## Revision of the International Standard for Notices to Skippers in Inland Navigation (resolution No. 80)

### Note by the secretariat

# Amendment proposal for the International Standard for Notices to Skippers in Inland Navigation

## II. Amendment proposal to the annex to resolution No. 80\*

**Figure 1**

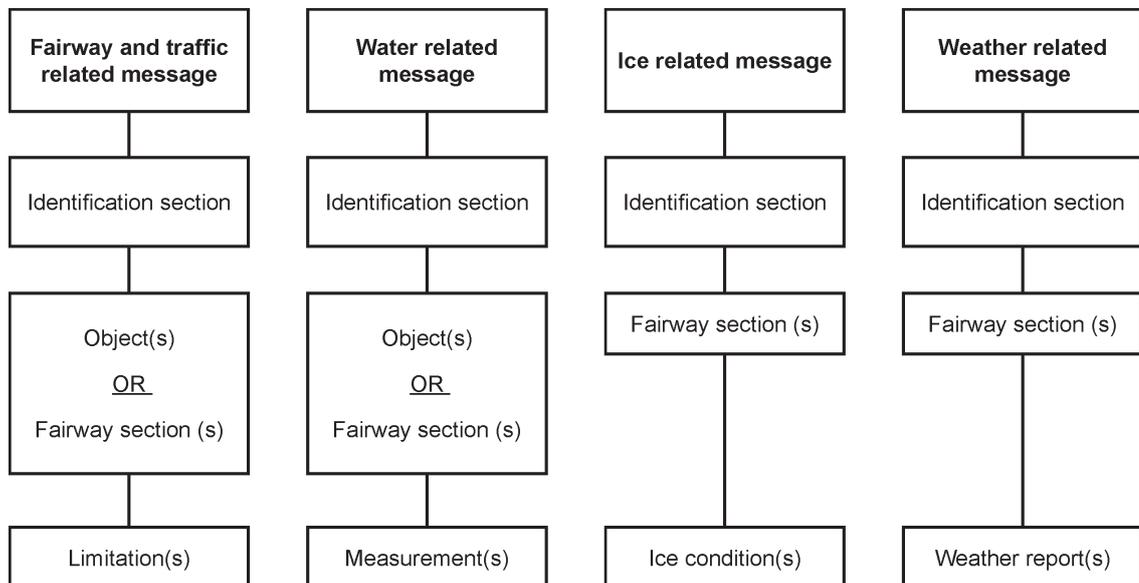
~~7.1.2—A standardized An NtS message in XML format contains therefore also 4 different consists of the following sections, in addition to the message identification mentioned in subparagraph (a) below, as shown in Fig. 7.1.2:~~

- (a) **Message identification section;**
- ~~(b) Fairway and traffic related messages—Section defining the applicable object(s) or fairway section(s) the message is related to;~~
- (c) **Limitation(s) for a fairway and traffic related message, measurement(s) for a water related message, ice condition(s) for an ice related message or weather report(s) for a weather related message.**
- ~~(d) — Ice messages;~~
- ~~(e) — Weather messages.~~

Figure 7.1.2 (deleted)

**Notice to Skippers message structure**

**4.1.1 Identification section**

Each message must contain an identification section. The identification section contains general information about the issuer and date of publication of the message.

**4.1.2 Fairway and traffic related message**

The fairway and traffic related message contains information for fairway section(s) or object(s), and it is used to indicate limitation(s) for the following purposes:
